2. An Important Finding of the NAS Committee is that LANL/DOE have Failed to Install a Reliable Network of Monitoring Wells in the Regional Aquifer.

Figure ES-1. Number of categories of residual drilling effects present in the most recent sample from each screen (as of December 31, 2006)

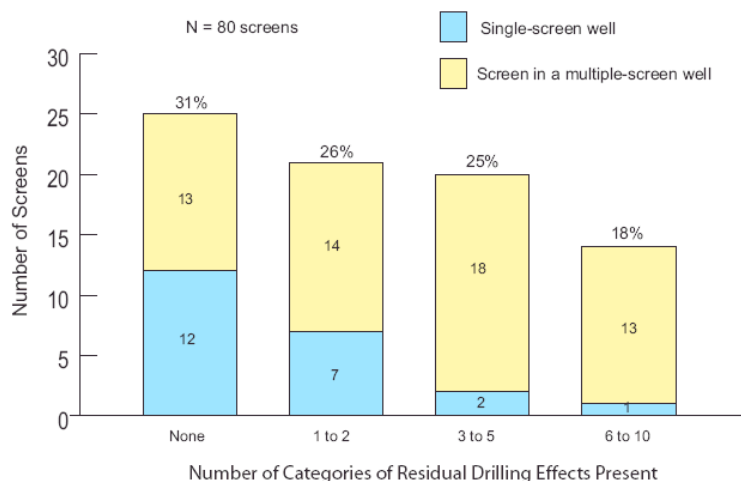
The above figure shows that 58 of the 80-screened intervals are in multiple-screen wells. The figure shows that an inherent problem with the assessment results in the WSAR-2 is that water samples are produced from 56 – *i.e.*, 70% of the screened intervals with no-purge sampling methods. Both the NAS committee and the staff of the New Mexico Environment Department describe the poor reliability of water samples collected with no-purge methods. Below is an excerpt from the NAS prepublication copy about the poor quality of the no-purge water samples:
